**East Kettering Approval of Condition Application
Planning Committee Update 18th December 2012**

AOC/0694/0706 – A14 Access Options

Revised Plans:

REVISED APPENDIX 4 DRAWING 3

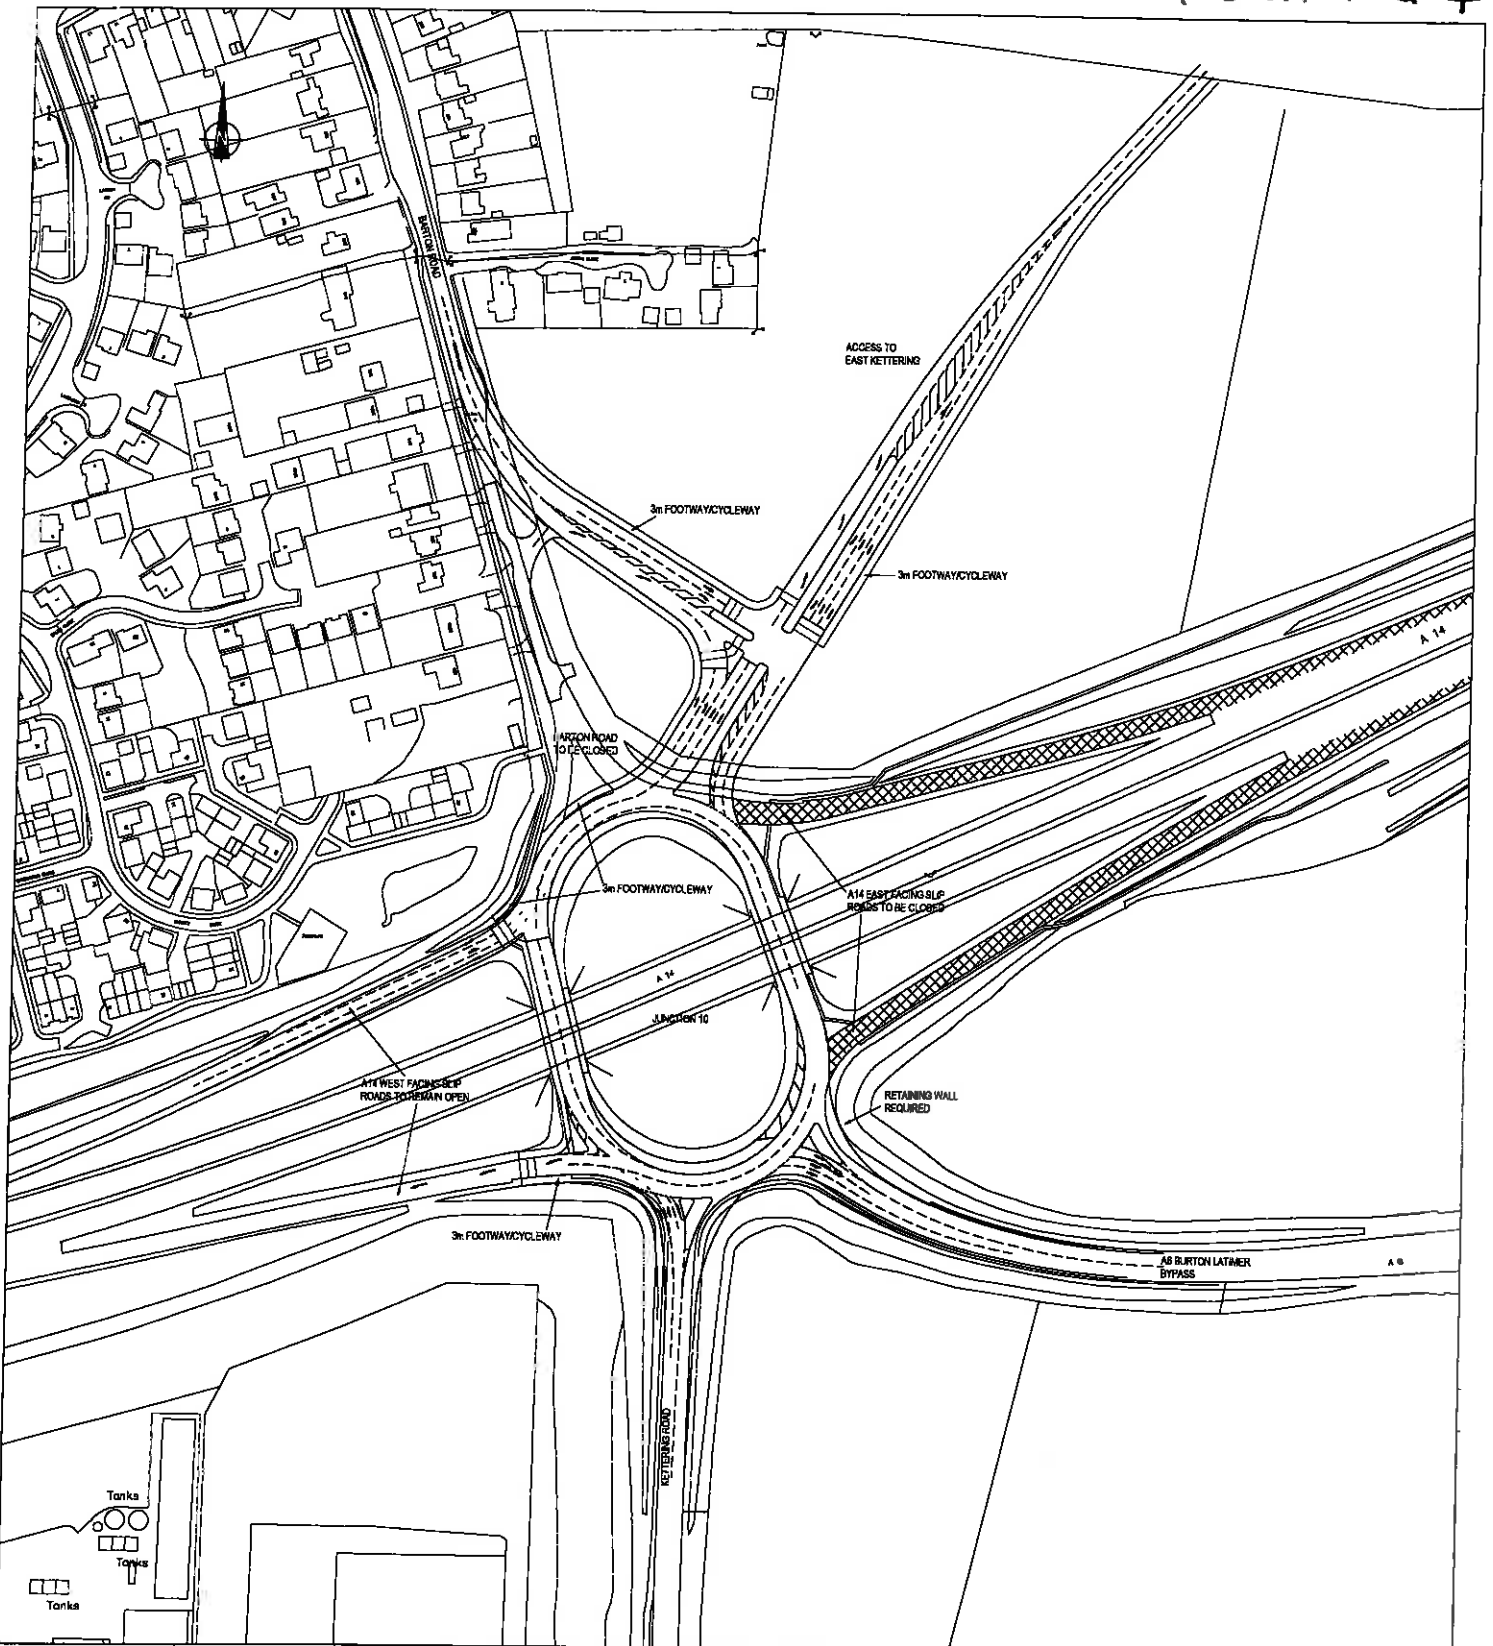
The applicant has submitted a revised Appendix 4 Drawing 3 and a revised Appendix 4 Drawing 4. Changes have been made to make the plans clearer.

B	FURTHER CLARIFICATION ON SLP ROADS ADDED	BNP	10.12.12	JH
A	LANE MARKING ALLOCATION TO BARTON ROAD EXIT AMENDED	JH	26.08.10	JH
Mark	Revision	Drawn	Checked	Checked
